**PSE&G** Public Service  
Electric and Gas  
Company

August 20, 1984

HOPE CREEK GENERATING STATION  
DOCKET NO. 50-354  
DRAFT SAFETY EVALUATION REPORT  
OPEN ITEM STATUS

Attachment 1 is a current list which provides a status of the open items identified in Section 1.7 of the Draft Safety Evaluation Report (SER). Items identified as "complete" are those for which PSE&G has provided responses and no confirmation of status has been received from the staff. We will consider these items closed unless notified otherwise. In order to permit timely resolution of items identified as "complete" which may not be resolved to the staff's satisfaction, please provide a specific description of the issue which remains to be resolved.

**FIGURE 220.21-29**  
**RESPONSE SPECTRA COMPARISON,**  
**AUXILIARY BUILDING AT ELEV. 102' -0",**  
**E-W, OBE, 2% DAMPING**

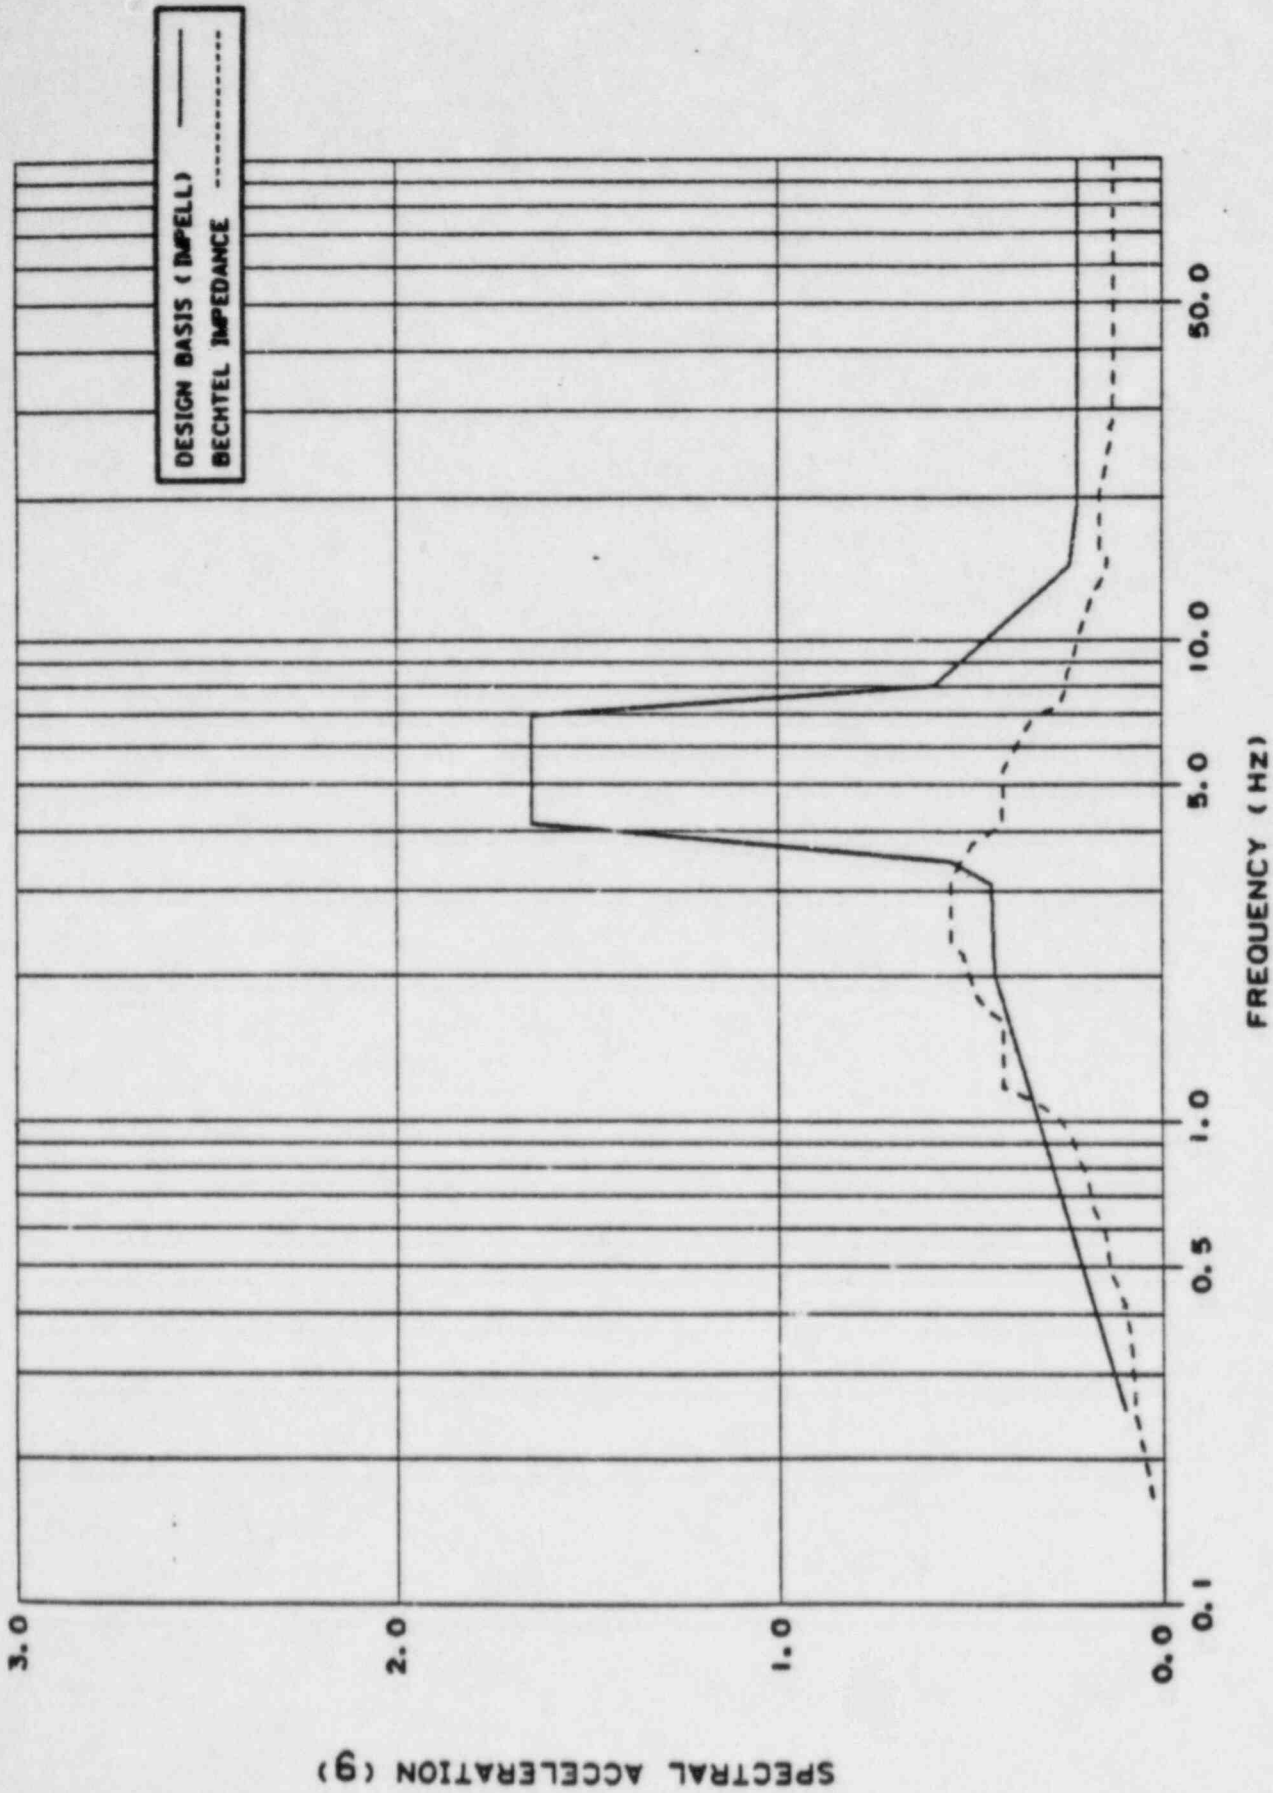
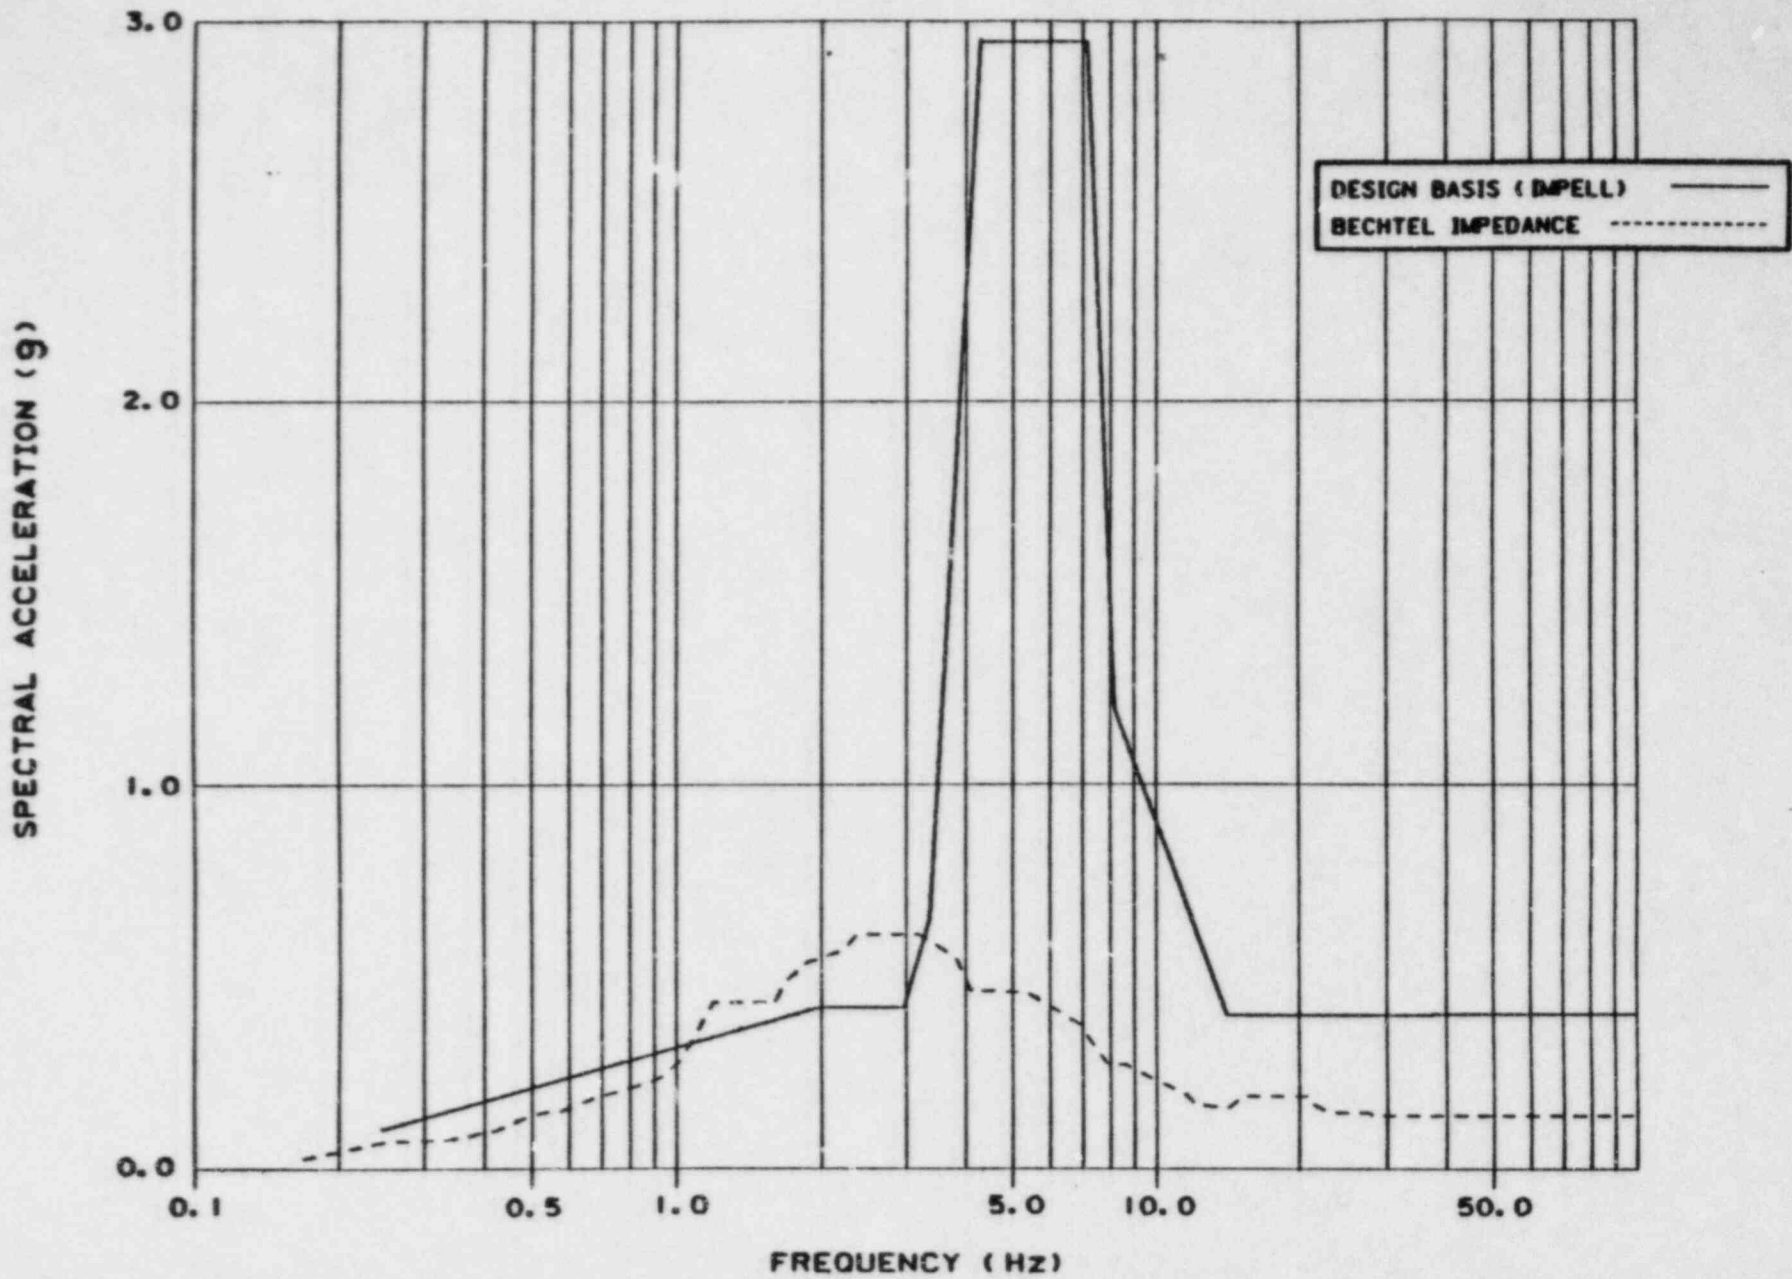
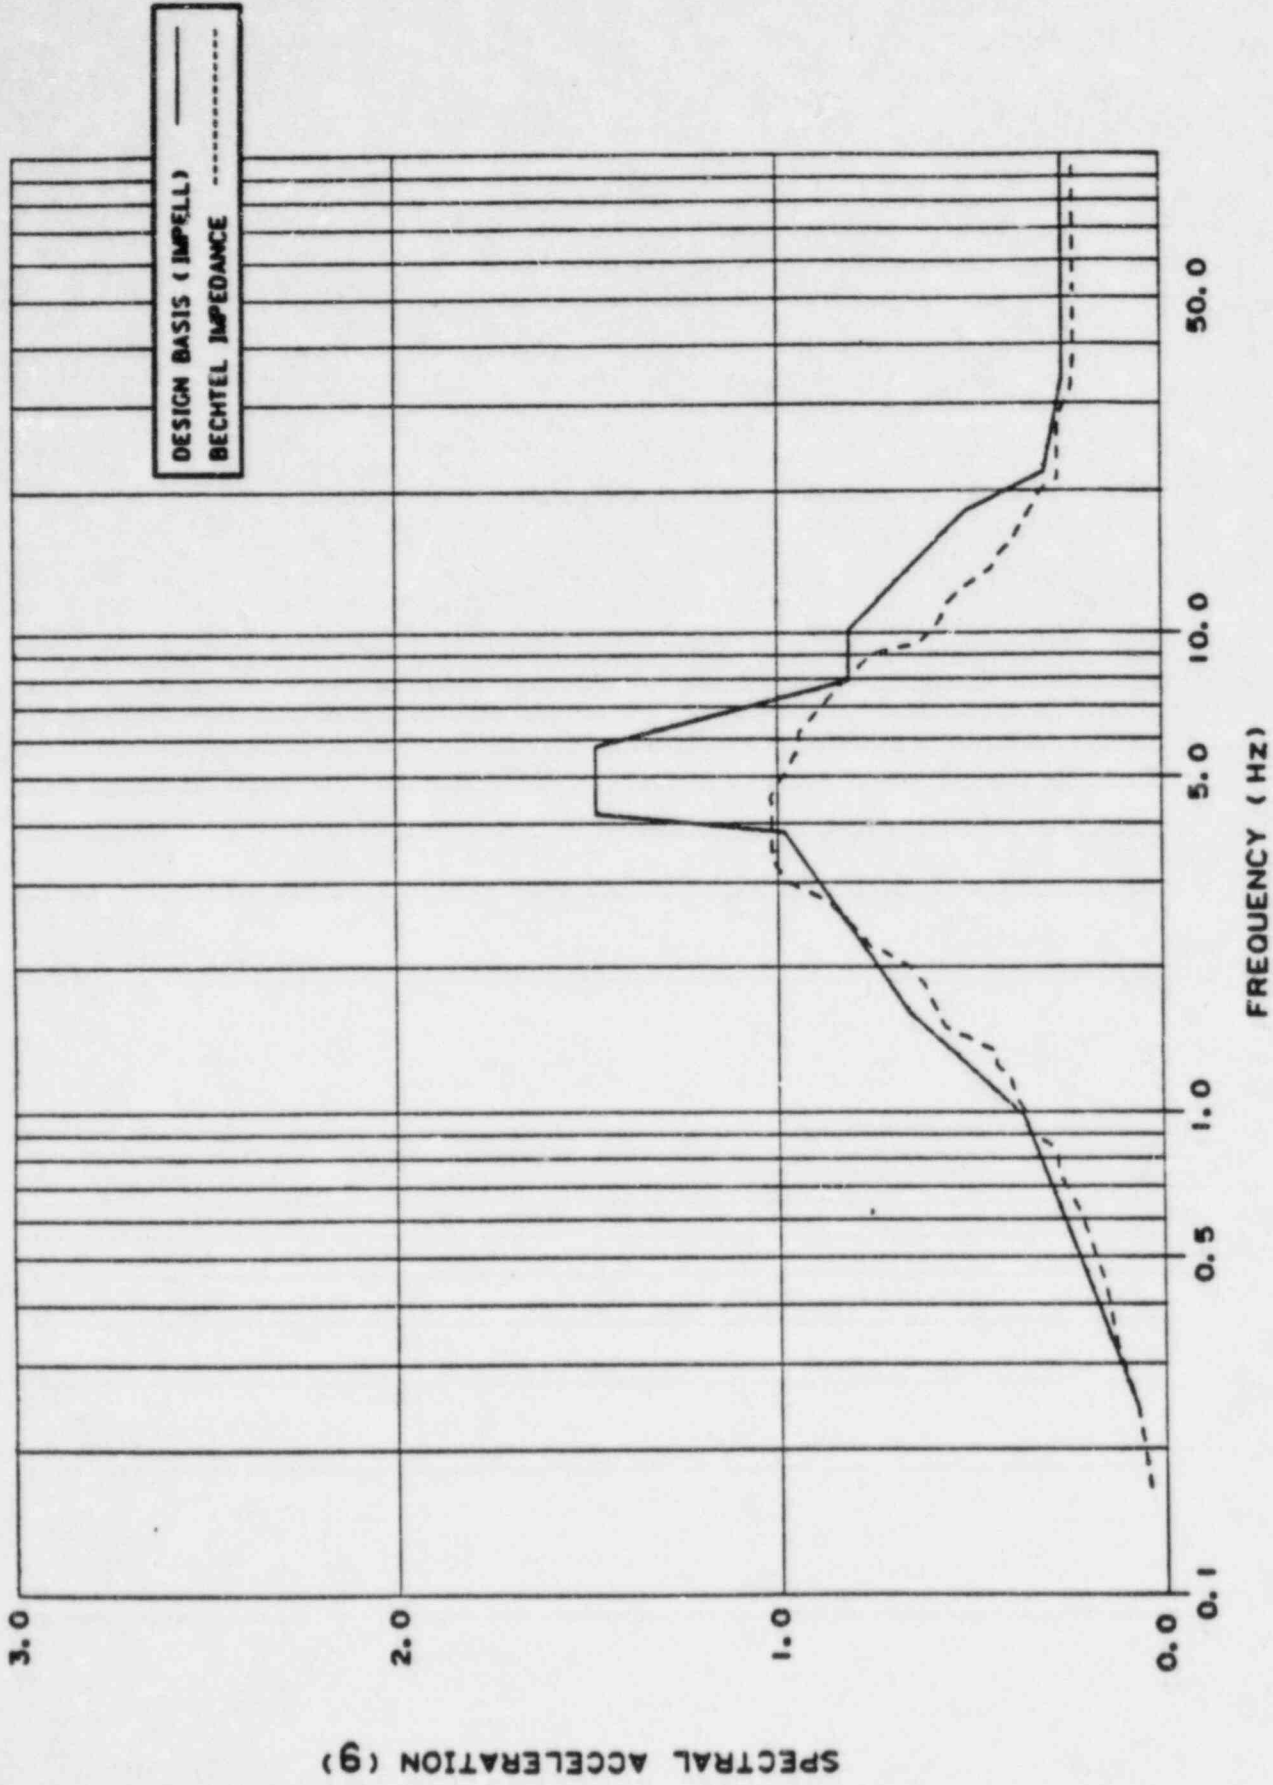
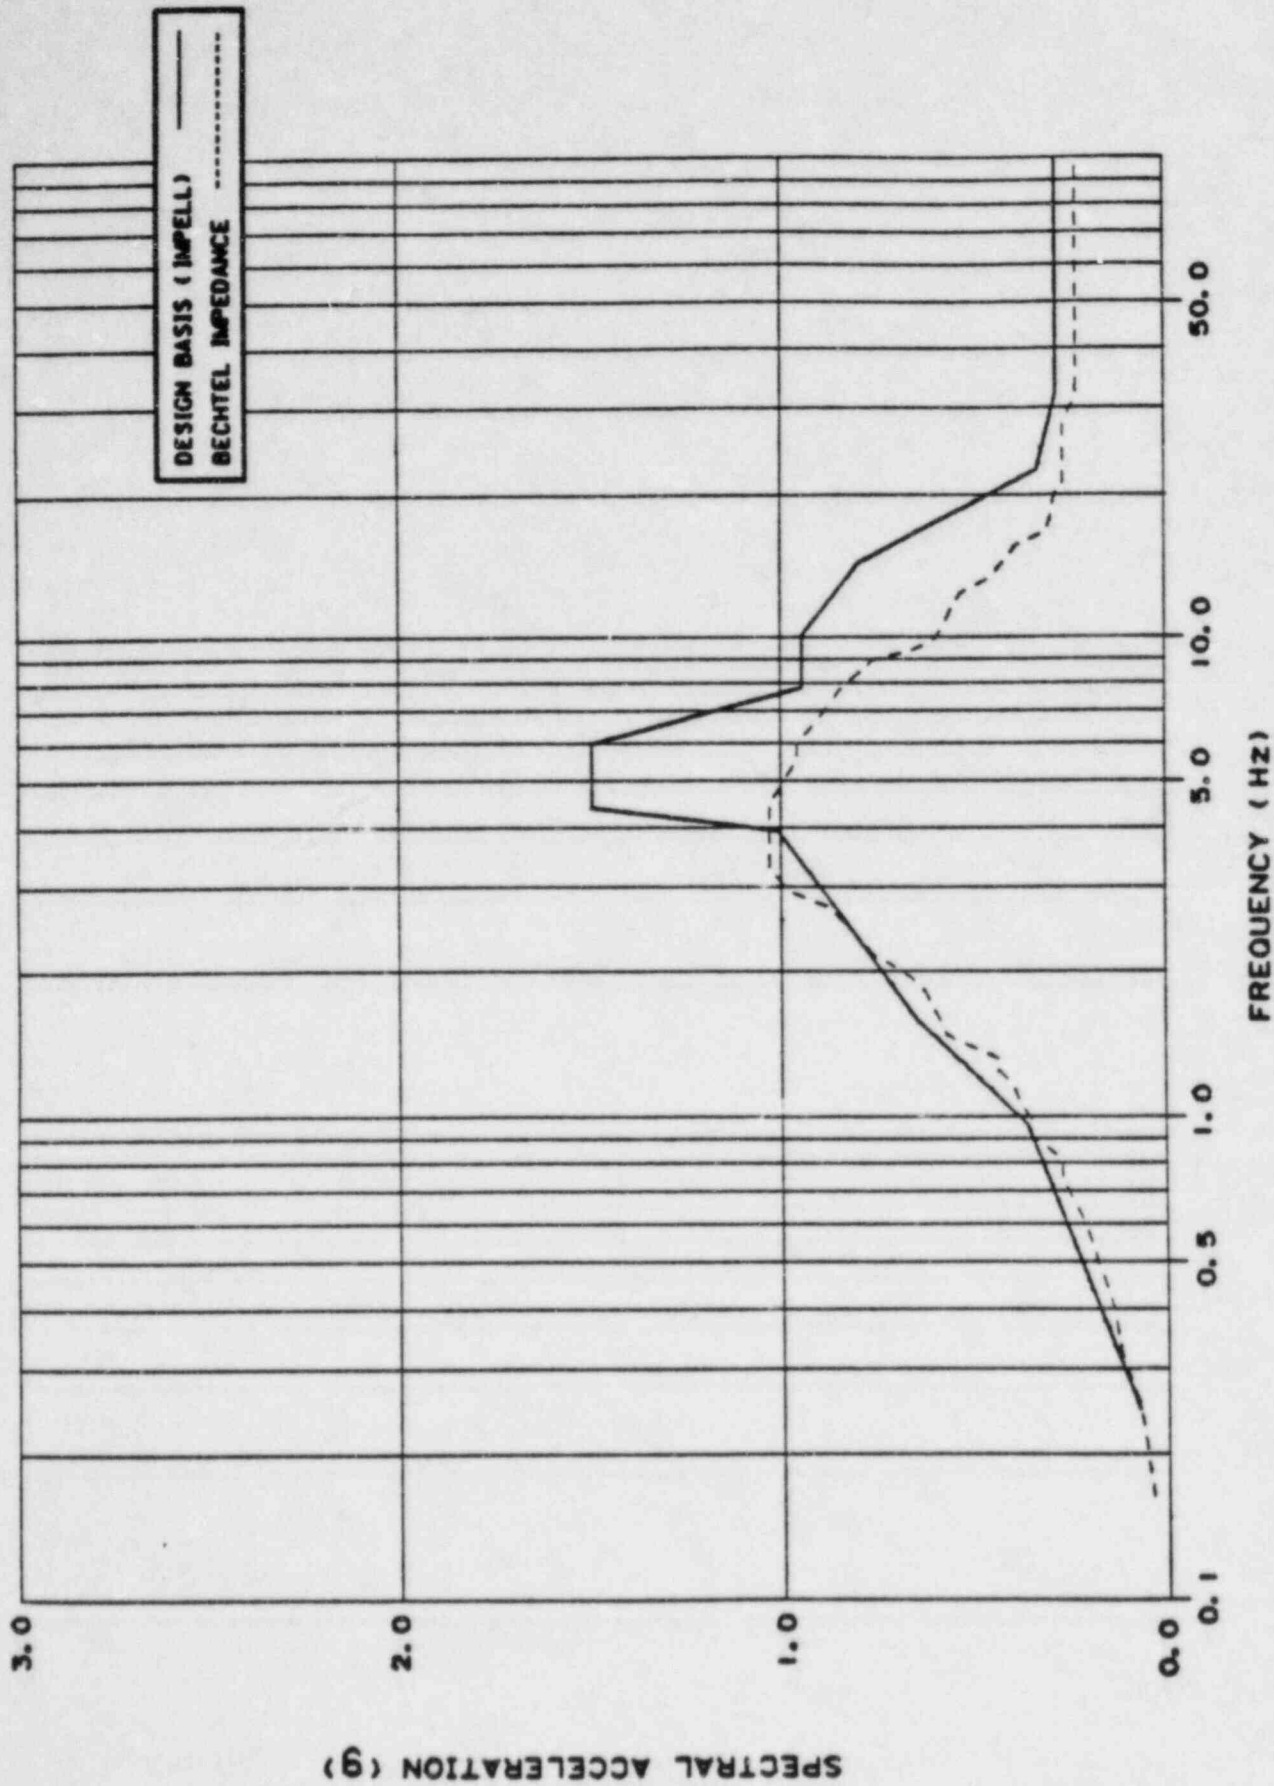
Figures 220.21-1 through 220.21-54 show a comparison of the 2 percent damping response spectra obtained from the design basis finite element and the impedance analyses for the reactor building, auxiliary building and the service water intake structure (SWIS).

¶ For the reactor and auxiliary buildings, the peak spectral accelerations obtained from the impedance analysis are generally lower than those obtained from the design basis analysis. However, the impedance analysis response spectra are not completely enveloped by those obtained from the design basis analysis, especially in the frequency range from 1.0 to 3.5 Hz. Also, there are some local exceedances in the higher frequency range, as shown in Figures 220.21-1 through 220.21-36. ¶ For the SWIS (Figures 220.21-37 through 220.21-54), the impedance analysis response spectra are generally enveloped by those obtained from the design basis analysis at elevation 114.0 feet. For other elevations, the impedance analysis spectral accelerations exceed the design basis spectral accelerations in some frequency ranges. These ranges vary approximately between 1.5 and 10.0 Hz.

In all cases, the items reviewed during these sampling studies can accommodate the loads resulting from the impedance analysis. Therefore, the impedance analysis results have no impact on the plant design.
